# E8356A-02E

# S E R V I C E N O T E

## E8356A PNA Series RF Network Analyzers

Serial Numbers: 00000000 thru 46999999

Figure 1

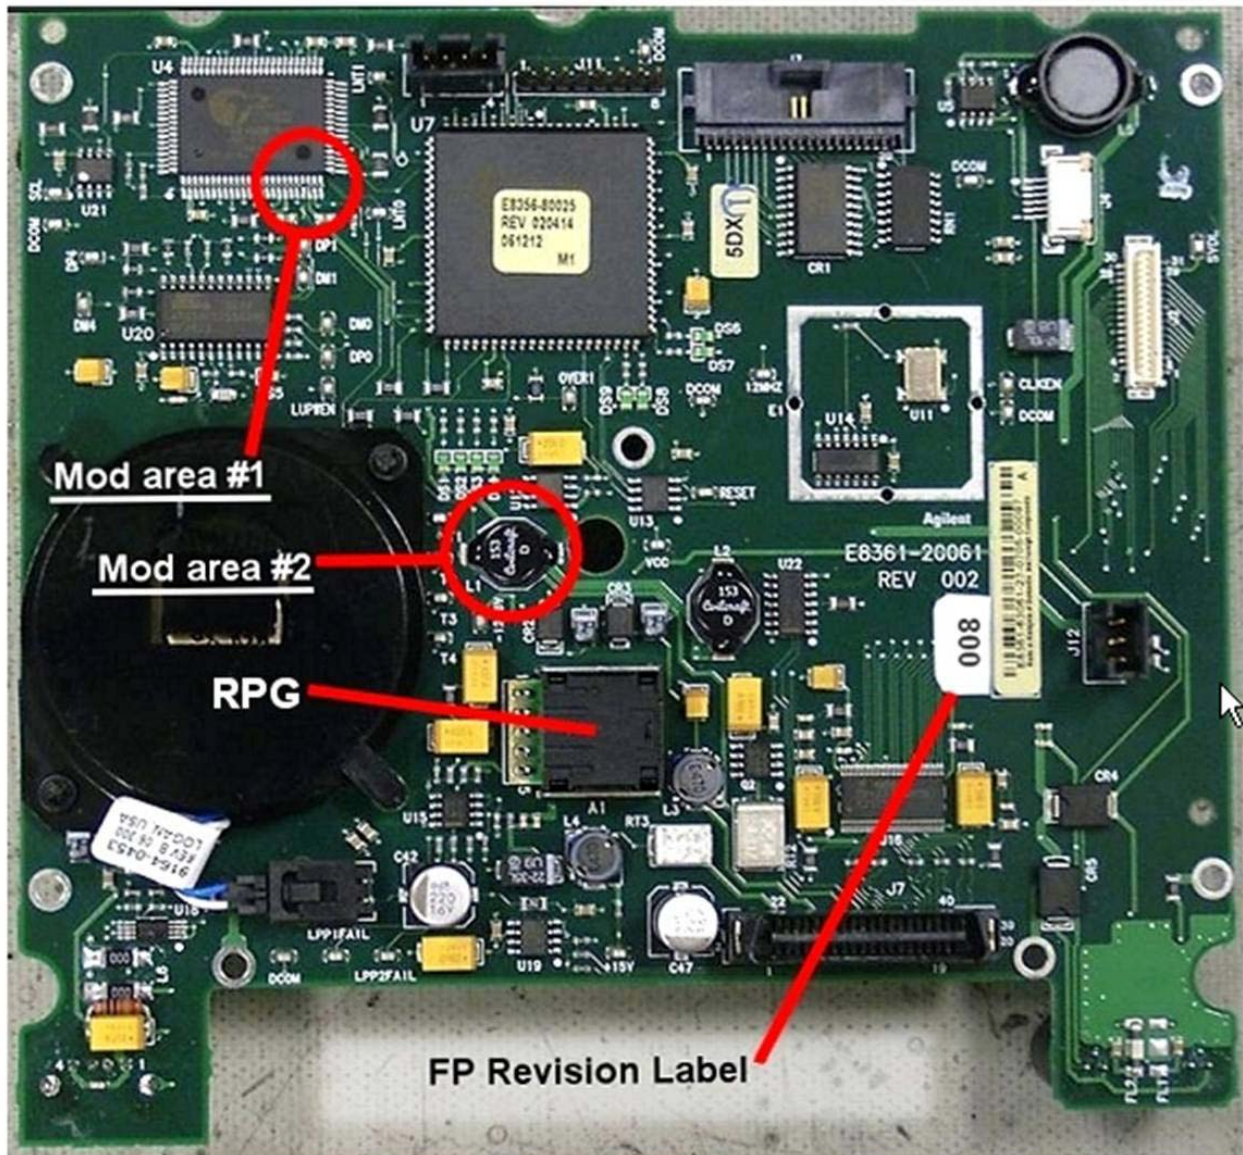
Refer to Figure 1 for the two modification areas to be addressed. Note that while this picture happens to show the FPI board completely removed from the front frame assembly, this is not necessary to perform the required modifications.

- Modification #1 consists of shorting two pins of U4 together with a small amount of solder.
- Modification #2 consist of removing L1.

Unsolder and completely remove the black surface mount inductor L1 from the front panel assembly board. This is no longer needed and can be discarded.

**Figure 2**

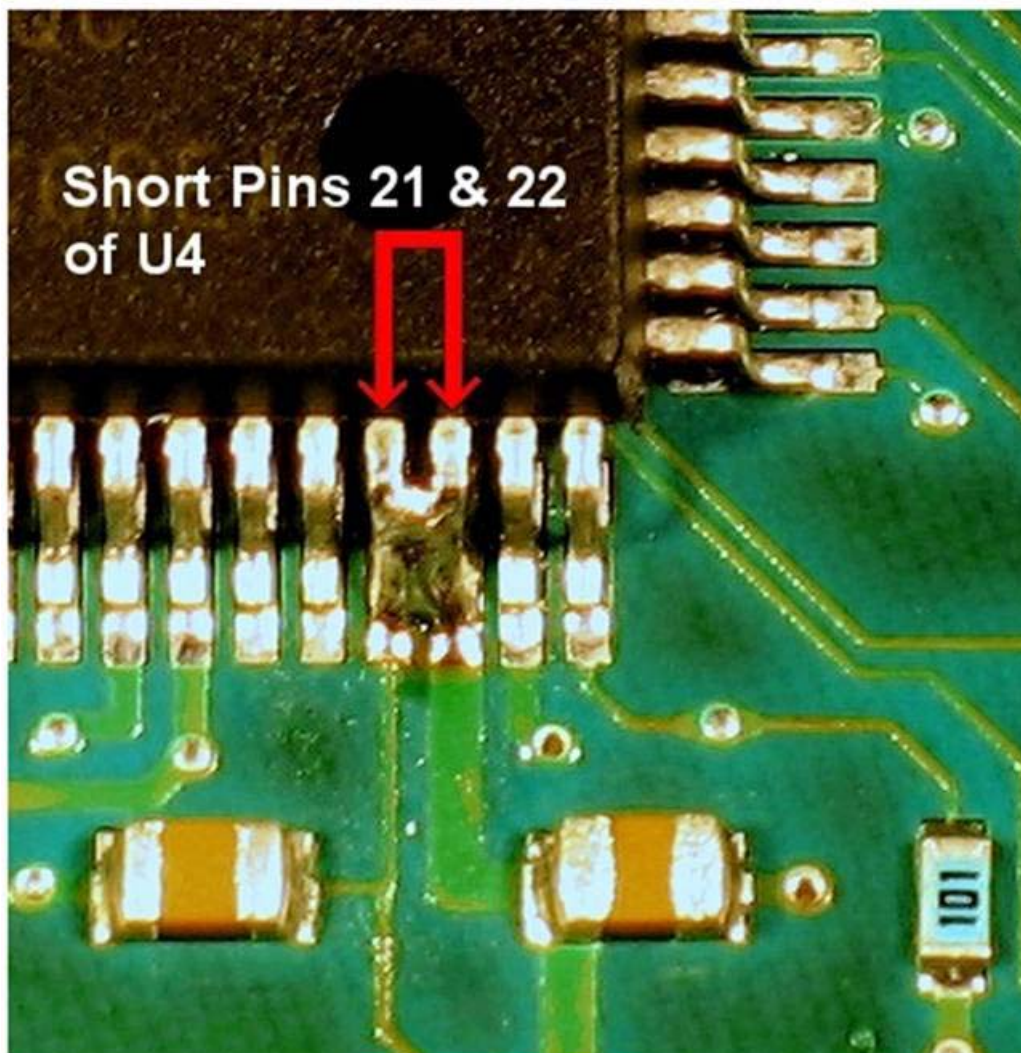
**Modification #1**

Carefully solder pins 21 and 22 together on U4. Refer to Figure 2 for the exact location. Use care so that no other pins are shorted. Use of a very fine tip soldering iron is recommended and a large work-task magnifying glass is very helpful.
